**Customer Advice Note
CAN #173**

**Galaxy Ethernet Module V4.15
V4.16**

A083-00-10, E080-10

Date: February / 2023

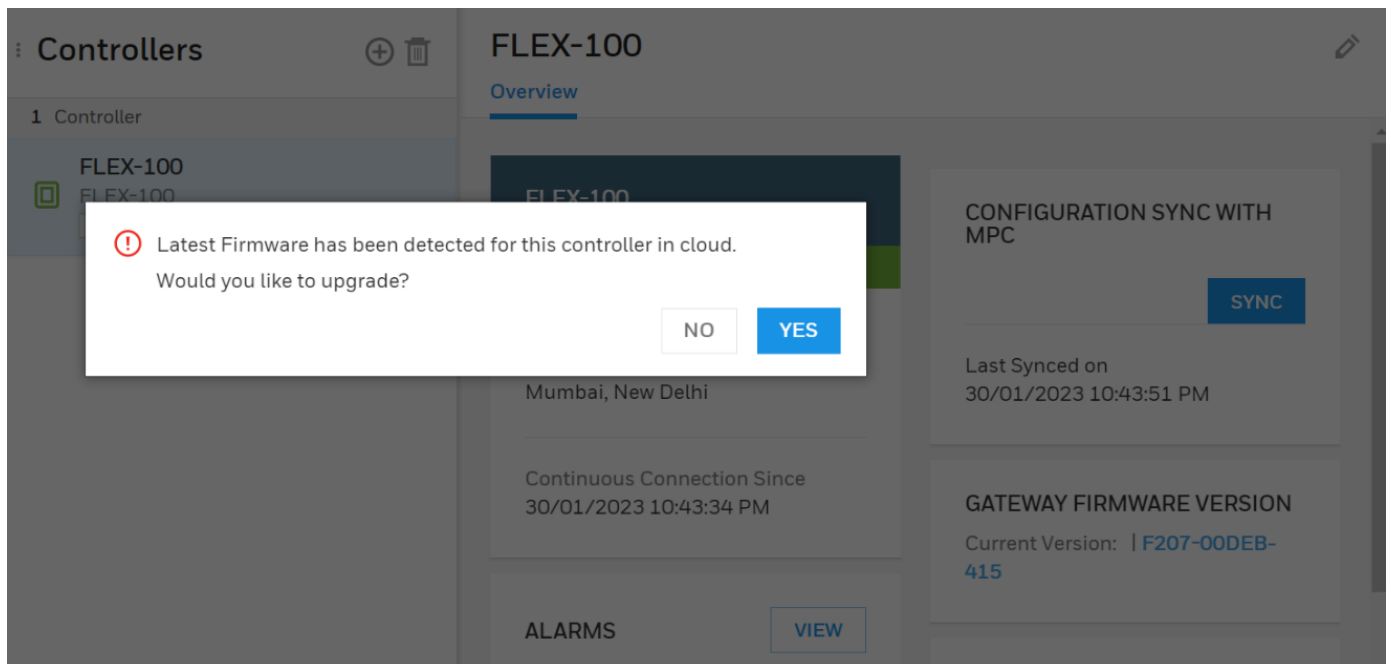
An update of the Ethernet module firmware can be completed via MAXPRO Cloud, updating the Ethernet module from **V4.15** to **V4.16**.

Note: Only the MAXPRO Cloud connected modules need to be updated to **V4.16** as this will address the zone descriptor problem experienced on MPC with V4.15. Modules not connected to MPC do not need this fix.

Note: All previous versions cannot be updated using this process. Only **V4.15** can be updated to **V4.16** via **MAXPRO Cloud**.

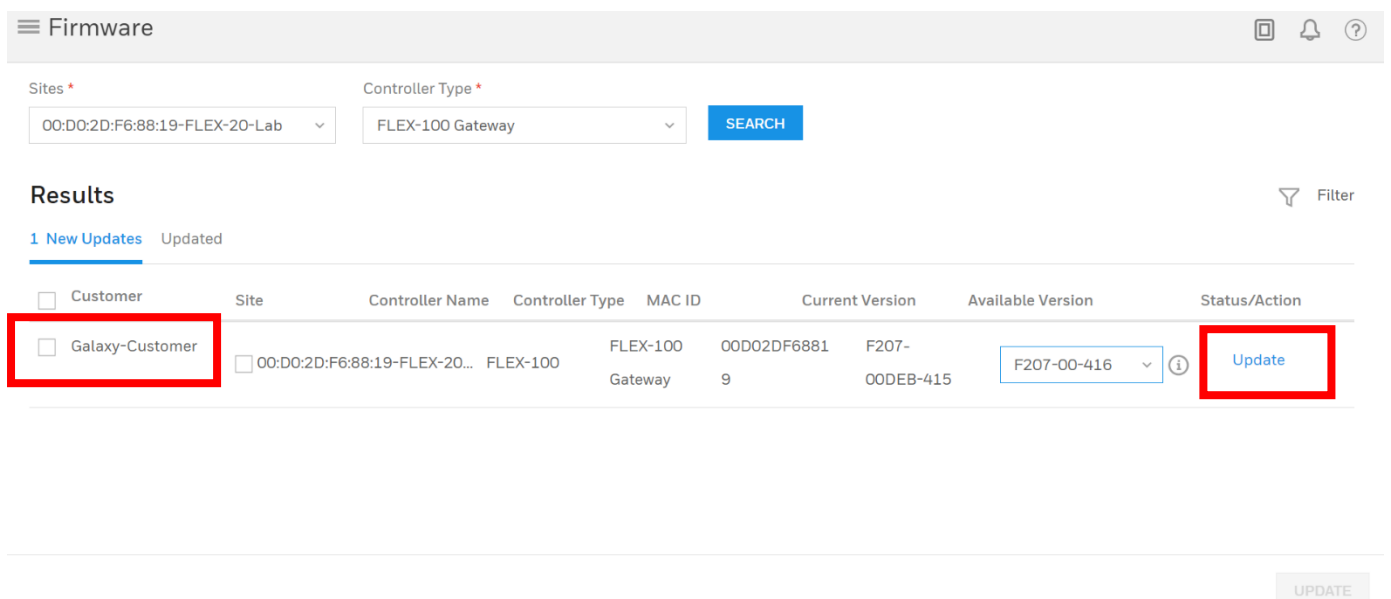
For new users registering Galaxy Panel with **V4.15** Ethernet module firmware in MAXPRO Cloud a pop up will be displayed as shown below select Yes.

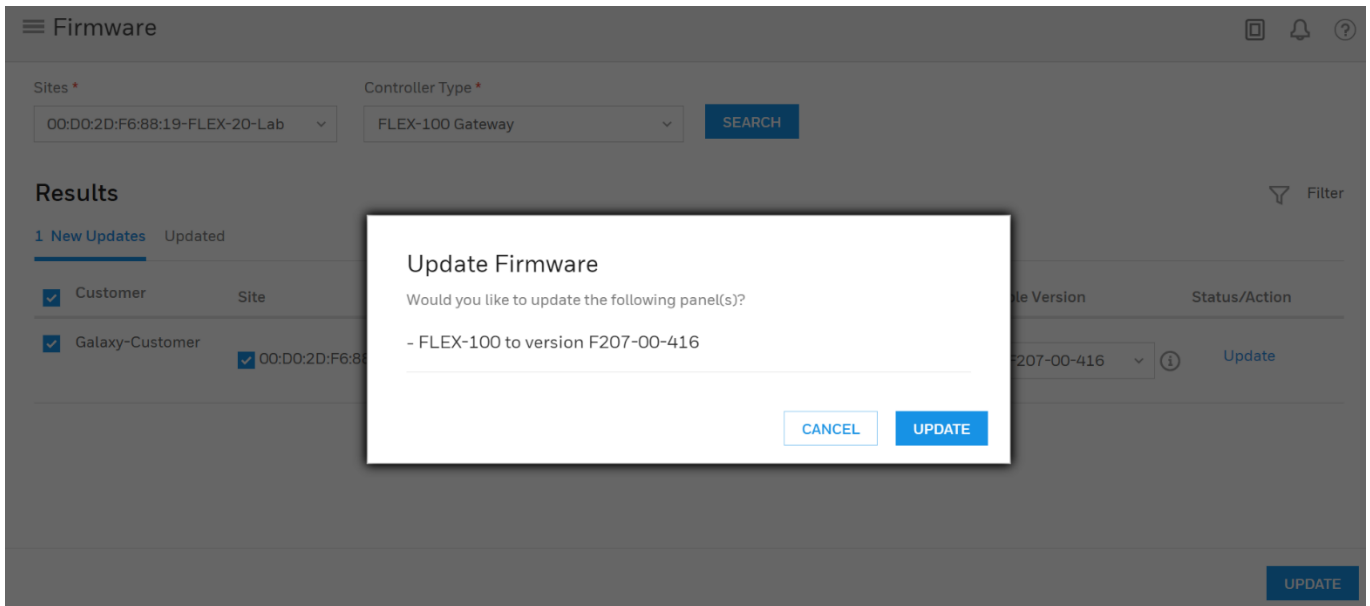
Once Yes is selected user will be taken to firmware menu with selected **site and module firmware** as shown in below screen. Select Customer / Site and click on Update
